# **One Carrington Street – Concept Plan Modification and State Significant Development**

**MP09\_0076 Mod 2 and SSD 5824**

Submission to NSW Department of Planning and Environment  
16 August 2014

**Figure 3. Weather awning along Broadway at Central Park development**

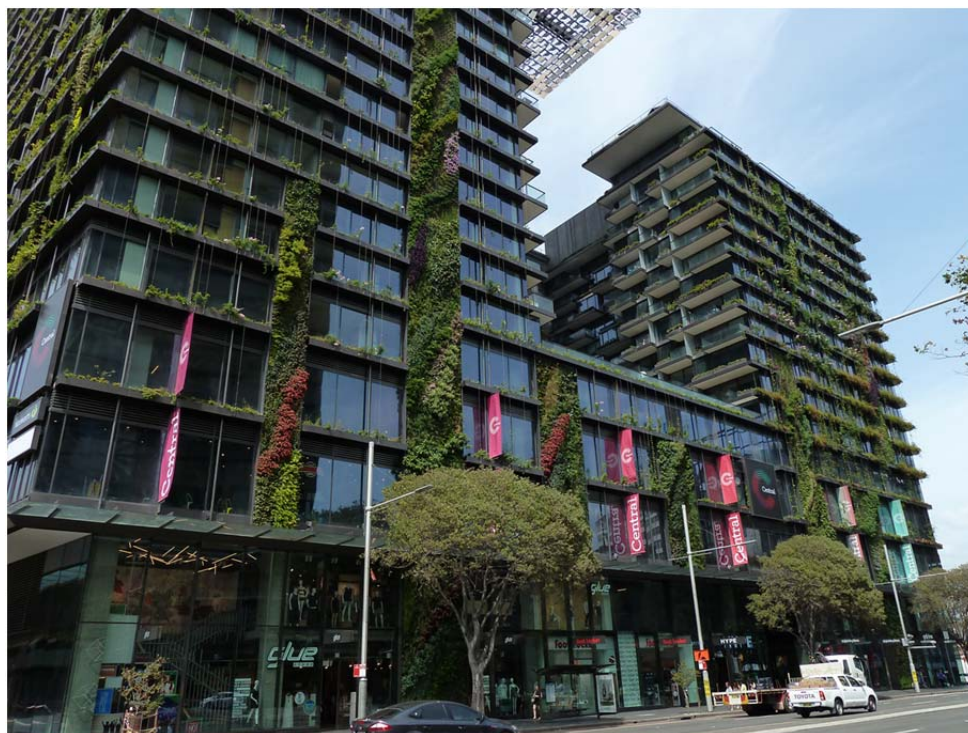
Examples of existing awnings that are similar in height to that proposed and provide limited weather protection at street level can be found at Westfield Shopping Centre along its Market Street, Pitt Street and Castlereagh frontages, and on Broadway at the Central Park development.

There is an absence of credible analysis submitted to support the excessive awning height currently proposed. The proponent's assertion that the proposed awning does provide adequate weather protection as well as identification of the Wynyard Station entry and maintaining sightlines through to Carrington Street is not supported. The proponent has not submitted sufficient information to demonstrate that a compliant awning in terms of height would adversely impact on sightlines from Carrington Street through to George Street, have any adverse impact on urban wayfinding or other undesirable architectural outcome.

Therefore any variation to the City's existing awning height controls is not supported and the City strongly objects to the current over-scaled awning design. It is disappointing that although this matter was raised during pre-submission consultation, it appears to have been given only cursory acknowledgement in the submitted package of information.
